RE: Position of Wetland 44a in Relation to Proposed Temporary Interchange at SR509 and S. 176th Street.

RE: Review of Wetland 44a in Relation to Proposed Temporary Interchange at SR509 and S. 176th Street.

Map 1. Map of sewer line showing locations of manholes, right-of-way fence and SR509 centerline. (Scale 1"=100 feet).

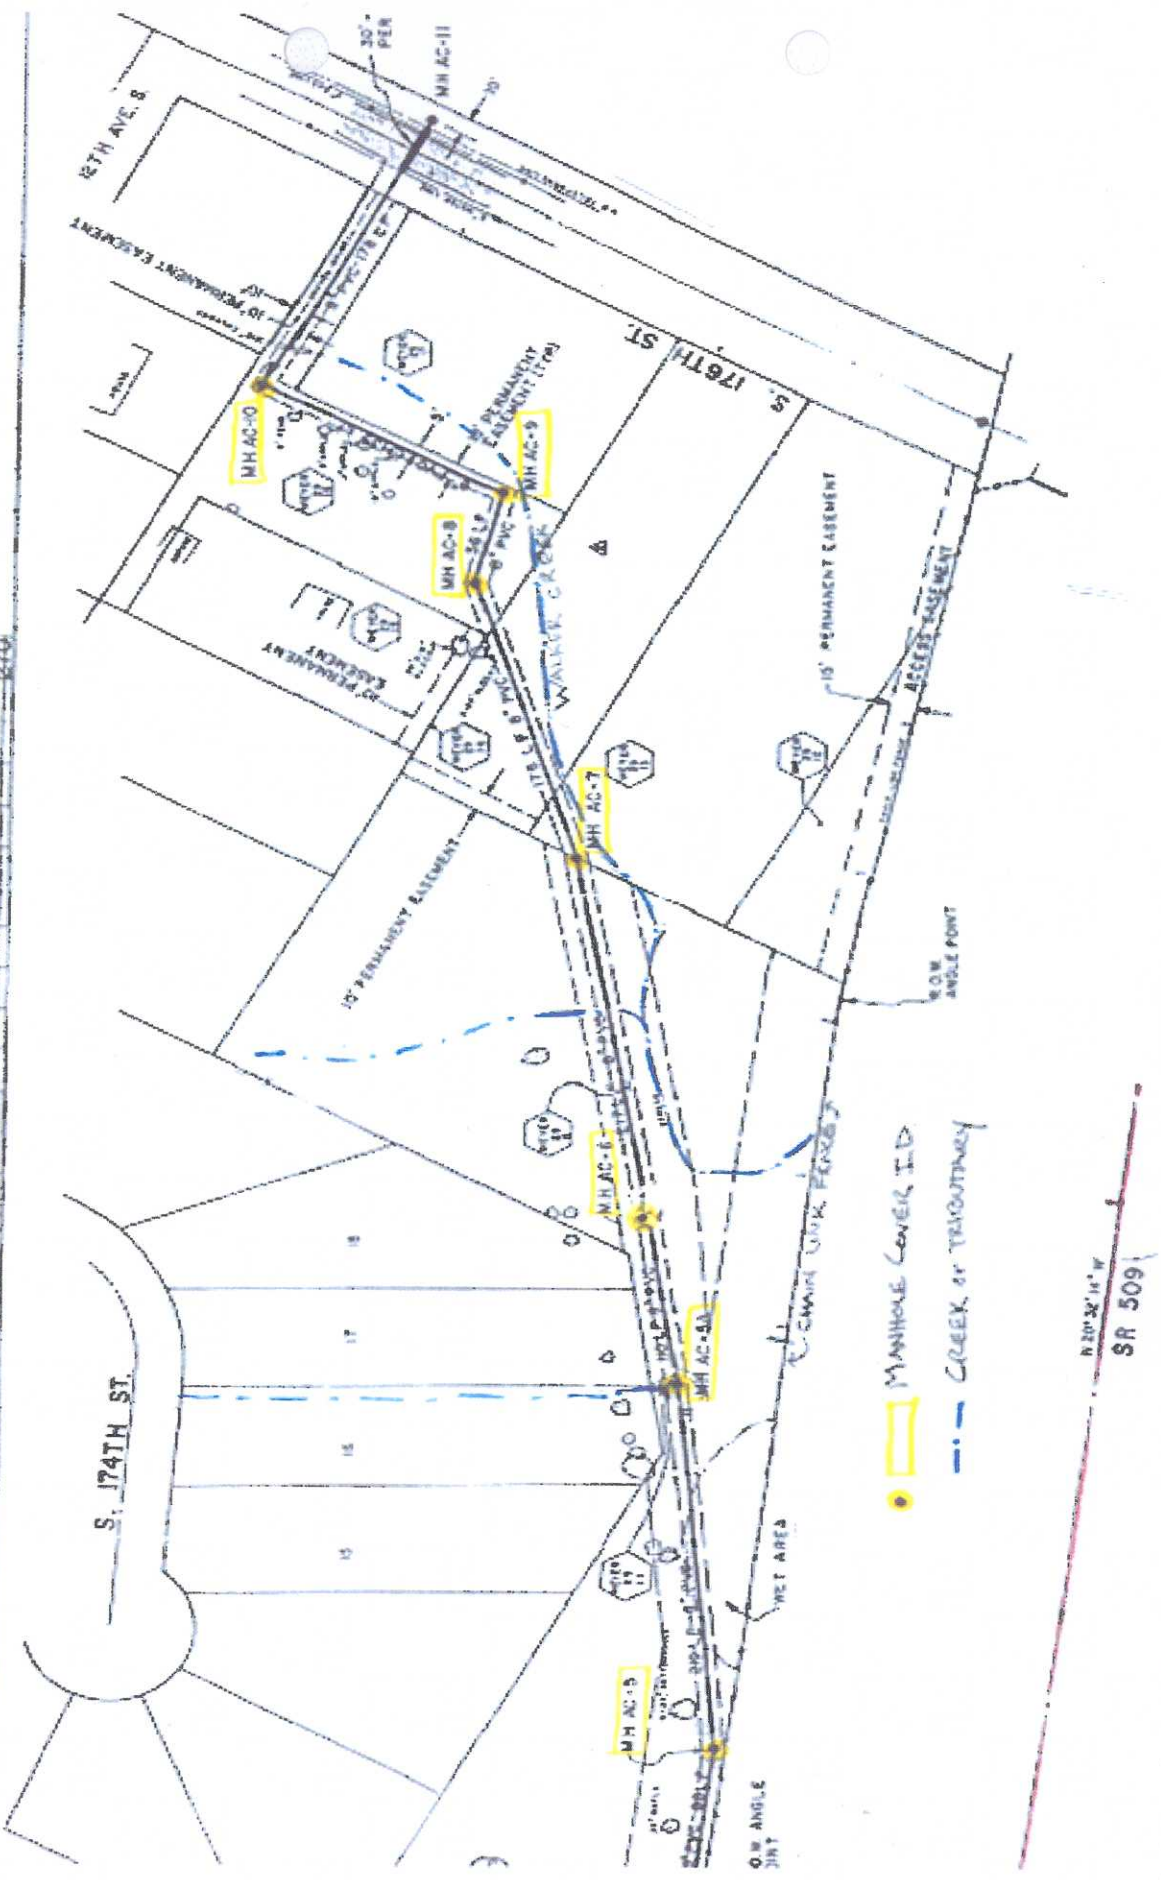
I visited the area on June 1, 2000 and, with the permission of adjacent property owners, walked west from S. 174th Street to Manhole AC-5 and the chain link fence located along the right of way of SR509 (shown on Map 1 of this report). Map 1 shows a sewer line, manhole locations and the chain link fence defining the right of way, in relation to SR509. The map was prepared for Southwest Suburban Sewer District in 1984. I located each of the manholes shown on Map 1 and noted their location in relation to the chain link fence shown to be on the right-of-way in Map 1 and Wetland 44a. I followed the fence south and noted the topography while reviewing the topographic map with the wetland boundaries provided in sheet GP-2 Grading Plan of the project plans prepared by HNTB along with the boundaries of the wetland provided by Parametrix in their May 3rd Memorandum.

Map 2. Partial overlay of wetland boundaries showing location of depression in red. Note that the red shaded depression on map is shown east of the right-of-way fence whereas it actually lies west of the right-of-way map. (Scale 1"=100 feet).

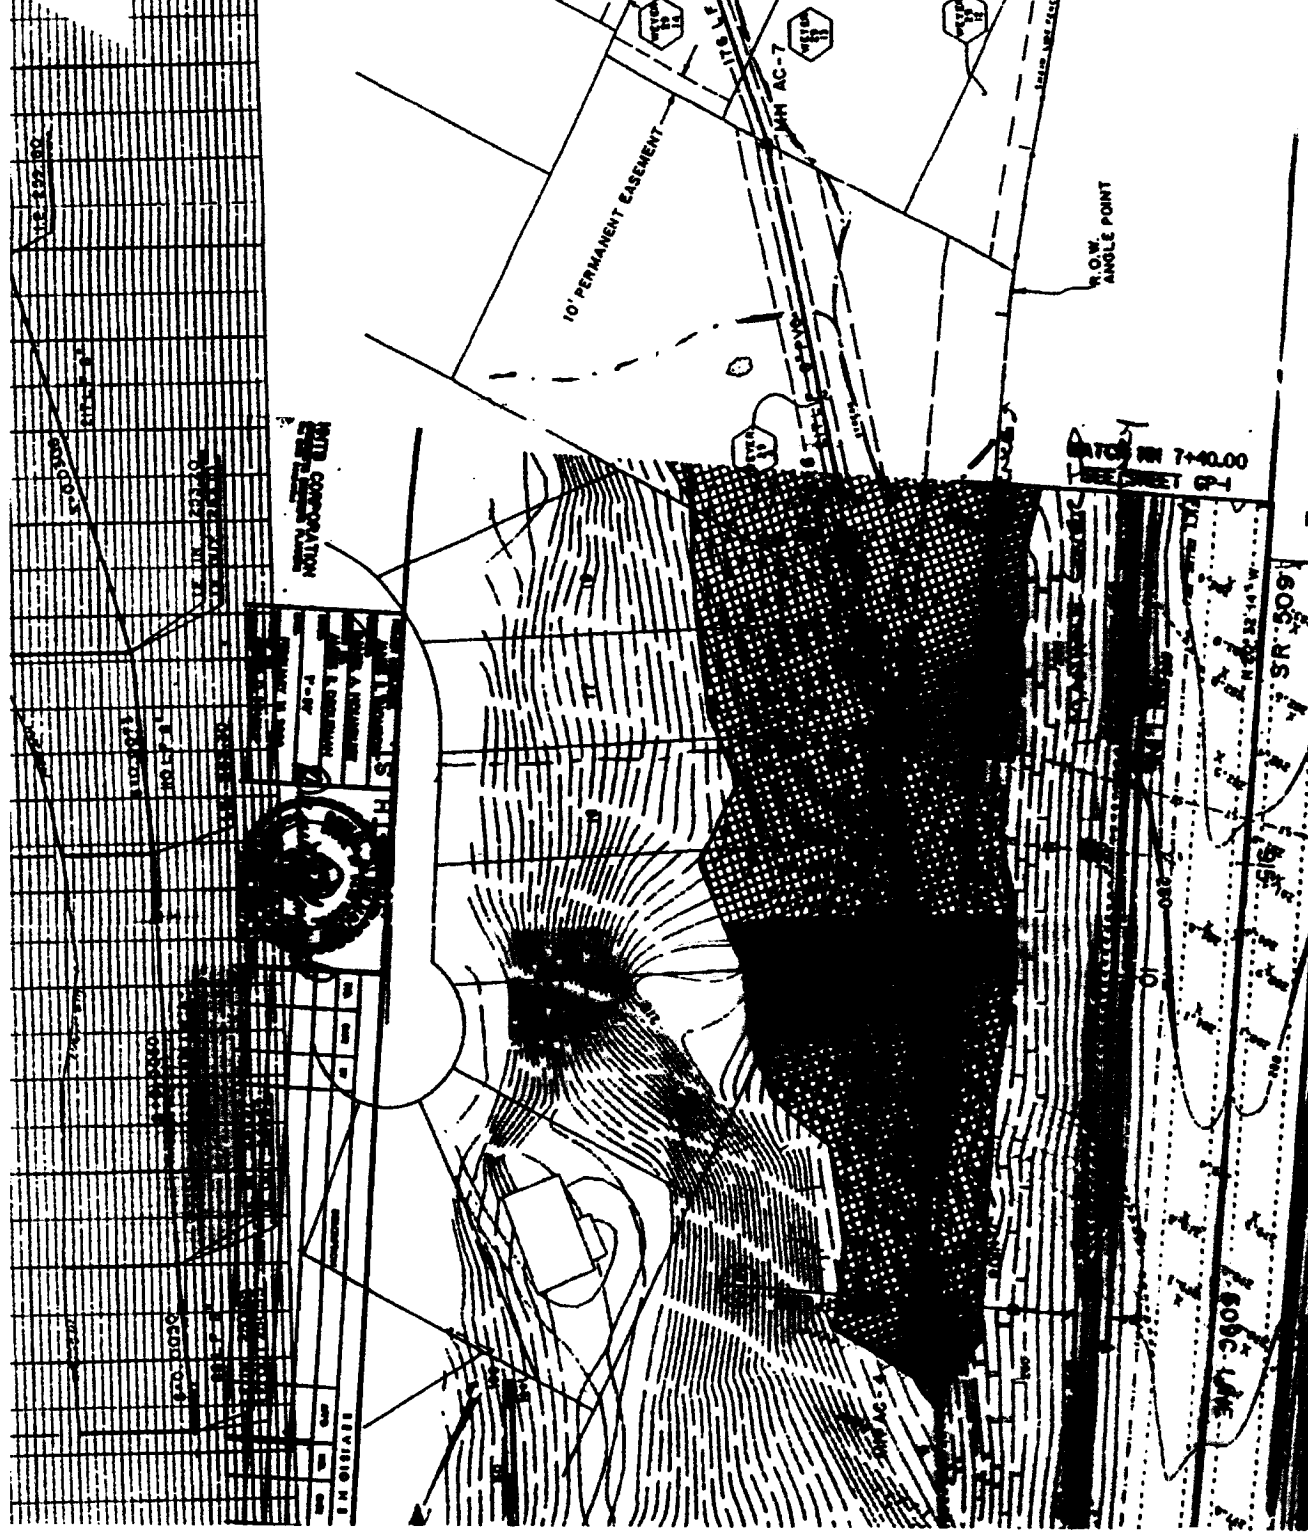
After visiting the site and reviewing the materials carefully, it is clear there is a significant discrepancy between what actual conditions are on the east side of SR509 and what is shown on sheet GP-2 Grading Plan in the project plans prepared by HNTB. Map 2 shows a portion of the GP-2 grading plan overlaid on Map 1, the sewer line plan. It is difficult to see the contours with the wetland shading superimposed but there is a depression located in the northern end of Wetland 44a. I shaded the bottom of the depression red to help you see it. During my field visit I stood on Manhole covers AC-5 and AC-5a (best seen on Map 1 on the left). From both manhole covers I saw the chain link fence located west along the right-of-way and, west of the fence, observed the depression shown in red on Map 2. From these observations, the depression appears to be located within the right-of-way, and not to the east of the right-of-way as is shown on the project plans and in the hydraulic report prepared by HNTB.

The depression I observed is clearly within the wetland and was located west of the chain link right-of-way fence. There were no other depressions in the area that could have been mistakenly identified. Based on the data available, it is reasonable to assume Wetland 44a may be 20 to 40 feet closer to SR509 than what is shown in the project plans. Under the circumstances it can be reasonably expected that significant impacts resulting from sedimentary discharges will occur to Wetland 44a as a result of the interchange construction.
